Re: Zoning Commission Case No. 08-21 (Athena Group LLC - Consolidated Review of a Planned Unit Development and Related Map Amendment @ Square 1356)

CANAL PARC
 MATTER OF RIGHT SITE PLAN

re CANAL PARC PUD BY-RIGHT SITE PLAN 23 April 09
DC Zoning Commission Case # 08-21

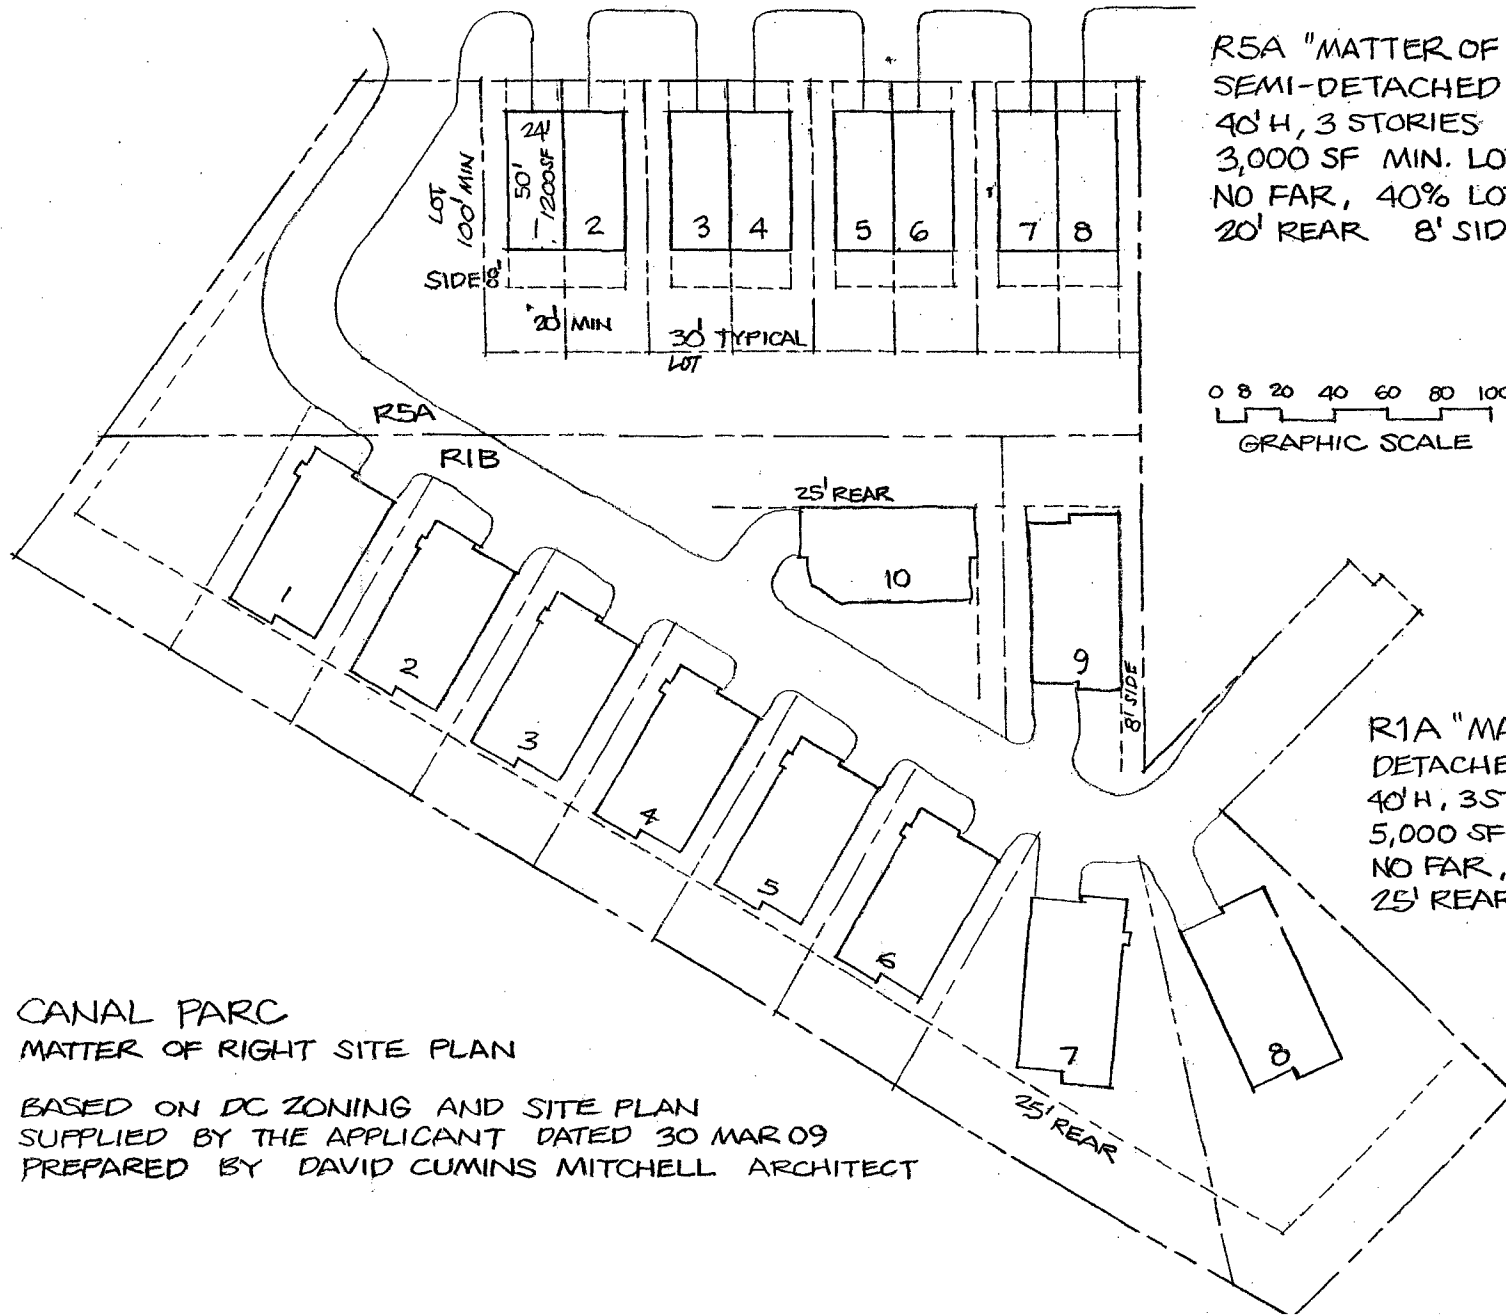
Therefore, the true matter of right should be based on the number of, best case, semi-detached dwellings that could be built matter of right. Architect David Mitchell has reviewed the Applicant's matter of right proposals and concludes that eight semi-detached dwellings would be possible as a matter of right in the portion of the property identified as R-5-A, in conformity with Zoning Regulations. A copy of the correct matter of right as developed by Mr. Mitchell and his supporting memorandum is attached.

According to this corrected matter-of-right plan, the Applicant could build a total of 18 dwelling units. This calculation means that **the actual relief requested is dramatically greater than what the Applicant has claimed**, and in no way approaches the superior standard called for in Planned Unit Development regulations.

The nine (1-9) single-family units meet the zoning code, however unit 10 has an Inadequate rear yard. Unit 1 proposes a curious condition in that it straddles the R5A, R1B property line. The box shown as the apartment building is a most offensive Blight on the land. Presumably it would be refined, if it would ever be seriously considered. The aerial perspective shows something akin to an ugly 1960s government office building. Such a structure would naturally have horizontal relief, balconies, a proper entrance and many elements protruding from the roof. The single-family houses appear monstrous in the aerial provided. At a full three stories, on a slab, they are out of scale and character with the neighboring Canal View houses. Unfortunately they are modeled after the two houses at the end of Lingan Road. It would be more in keeping with the neighborhood if they were two stories plus a basement and a roof with dormers. The apartment building shown is an affront to any viewer. As shown, the drawing is a nasty threat used as a tool to fly in the face of PUD opposition.

Finally, I stand by my earlier statements regarding parking. The apartment layout Calls for 29 spaces for 29 units. As previously stated, in practice this would be woefully inadequate. I strongly suggest as many as 58 spaces. Without adequate on-site parking, the pressure for street parking, which at times is non-existent, will spread through out the neighborhood. This will make for a goodly number unhappy neighbors and residents.
